# UNITED STATES PATENT AND TRADEMARK OFFICE

APPLICATION NO.	FILING DATE	FIRST NAMED INVENTOR	ATTORNEY DOCKET NO.	CONFIRMATION NO.
10/760,409	01/21/2004	Gerard D. Agnew	84732/2900 TAL	1209
20736	7590	11/03/2006	EXAMINER	
MANELLI DENISON & SELTER 2000 M STREET NW SUITE 700 WASHINGTON, DC 20036-3307			MERCADO, JULIAN A	
			ART UNIT	PAPER NUMBER

<b>Office Action Summary</b>	<b>Application No.</b> 10/760,409	<b>Applicant(s)</b> AGNEW ET AL.	
	<b>Examiner</b> Julian Mercado	<b>Art Unit</b> 1745

Fig.10.

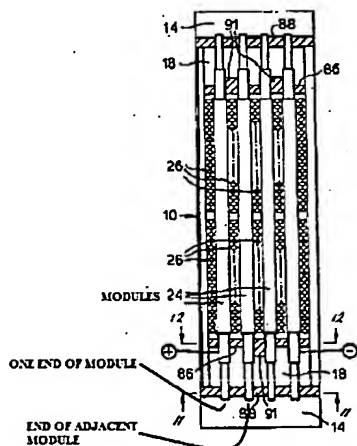
For claim 1, Gardner et al. teaches a solid oxide fuel cell stack [10] comprising a plurality of modules [24], each module comprising an elongate hollow member [36] each hollow member having parallel flat surfaces and a plurality of hollow passages [30] extending longitudinally therethrough for the flow of a reactant, as shown in Figure 4. (also applies to claim 4) See col. 5 lines 1-30. The modules include a plurality of solid oxide fuel cells [22] arranged on the flat surfaces of the modules. (Figure 4, ib., see also col. 8 line 29 et seq.) Figure 10 shows that adjacent modules [24] are arranged substantially parallel and spaced apart, as shown in Figure 10, appended herein:

Fig.21.

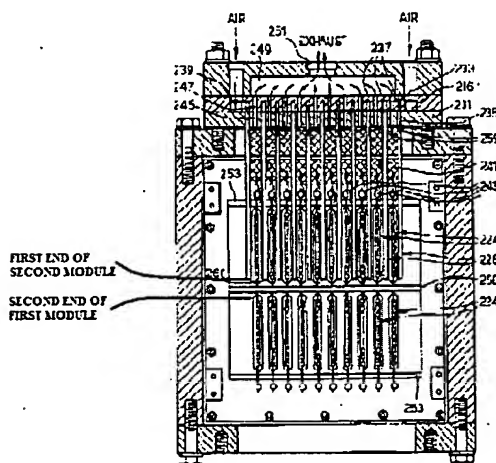
In applying Gardner et al. as a basis for rejection, the examiner notes that claim 1 merely recites “one end... being connected to an end of an adjacent module...”, and reference characters [34] and [36] are used to designate the claimed “one end” and the claimed “end of an adjacent module” (respectively), the examiner asserts that while claims are read in light of the specification, limitations that may be ascertained from the specification or its drawings are not read into the claims. Accordingly, the limitation drawn to “one end... being connected to an end of an adjacent module...” has been given its broadest reasonable interpretation such as shown by Gardner et al., e.g. the first end of a first module being adjacent a first end of a second module, e.g. disposed end-to-end in parallel, as shown in Figure 10, while also showing a plurality modules [224] whereby the second end of a first module is adjacent a first end of a second module, e.g. disposed in end-to-end in series, as shown in Figure 21, appended herein:

examiner asserts that the instant “solid oxide fuel cell stack” must be distinguished from the prior art in terms of structure rather than function. Notwithstanding, Figure 21 such as shown above is considered to show modules disposed sequentially such that from a functional standpoint, the resultant flow is in sequence, i.e. flowing from the first module and into the second. See col. 14 line 13 et seq.

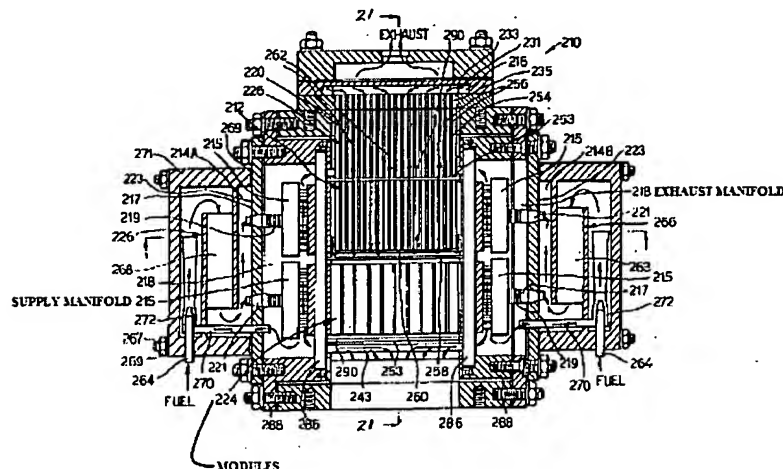
For claim 2, a manifold [215] is for the supply of a reactant and a manifold [218] is for the removal of the reactant. See col. 12 lines 52-58. As discussed above, each module [224] has the second end of a first module adjacent and connected to a first end of a second module, as shown in Figure 21. (also applies to claim 3) Figure 19 is relied upon to further show that the ends of the series of modules [224] are connected to the manifolds [215] and [218] for supply

and removal of the reactant, respectively. (ib.) Annotated Figure 19 is appended herein:
